SERVICE BULLETIN

No: SB_SD4-01-2021

MODEL AFFECTED:	EASA-TCDS No. EASA.A.606, Issue 3, 01.April 2019
APPLICABILITY:	<p>Criterion A) Aircrafts Viper SD-4 RTC aircrafts</p> <p>Criterion B) NAV LIGHTS & STROBE: Each Viper SD-4 RTC aircraft equipped by Ultra Galactica Green; P/N: AVE-WPSTG-54G Mod (4) and Ultra Galactica Red; P/N: AVE-WPSTR-54G Mod (4) installed during aircraft manufacturing, repair, maintenance or general overhaul or any other exchange action.</p> <p>Criterion C) Automatic Circuit Breaker (ACB): Each Viper SD-4 RTC aircraft equipped by E-T-A 2215-G111-P1F1-S0-5A ACB on position STROBE and E-T-A 2215-G111-P1F1-S0-3A ACB on position NAV LIGHTS installed during aircraft manufacturing, repair, maintenance or general overhaul or any other exchange action.</p>
SUBJECT:	Exchange of STROBE (E-T-A 2215-G111-P1F1-S0-5A) ACB and NAV LIGHTS (E-T-A 2215-G111-P1F1-S0-3A) ACB on Viper SD-4 RTC aircrafts equipped with AVE-WPST[G/R]-54G Mod (4) series Navigation / Position / Strobe LED lights. ATA System: 24-60 Electrical Load Distribution.

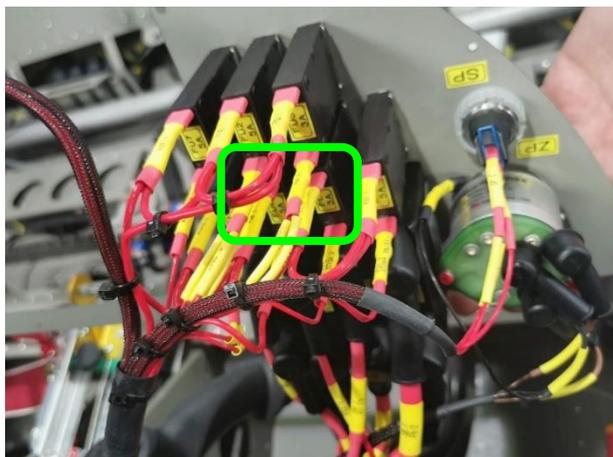
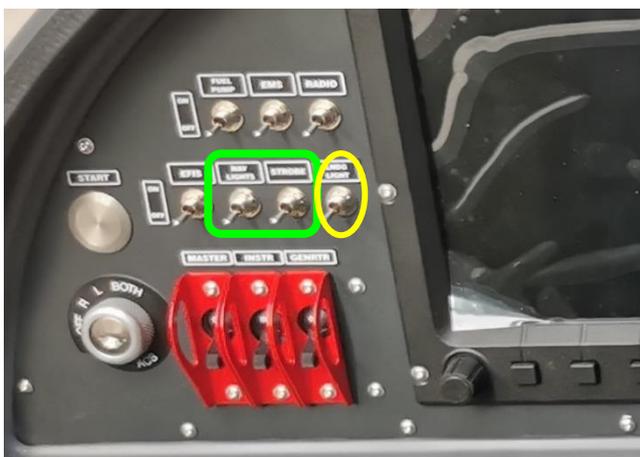
- 6. The original circuit breakers are in the lower row, marked with labels as NAV LIGHTS and STROBE. When seen from the back side, the circuit breakers on the instrument panel are marked as FL (NAV LIGHTS) and FU6 (STROBE).

- The circuit breakers are marked on their back sides with labels containing their marking and amperage: "NAV LIGHTS" = FL / 3A, "STROBE" = FU6 / 5A, "LNDG LIGHT" = FU12 / 1A

- I) *FU6/5A* (2215-G111-P1 **F1**-S0-**5A**) for the *STROBE*,
 - II) *FL/3A* (2215-G111-P1 **F1**-S0-**3A**) for the *NAV LIGHTS*,
- use the NEW circuit breakers marked with the same labels:
- 1) *FU6/5A* (2215-G111-P1 **T1**-S0-**5A**) for the *STROBE*,
 - 2) *FL/3A* (2215-G111-P1 **T1**-S0-**3A**) for the *NAV LIGHTS*.

10. Mount the NEW circuit breakers on the instrument panel in the right order from the back. Along with the mounting, connect the wires according to the markings on them and the order of the circuit breakers. Be careful - The order of the circuit breakers for the mounting on the instrument panel is not changed.
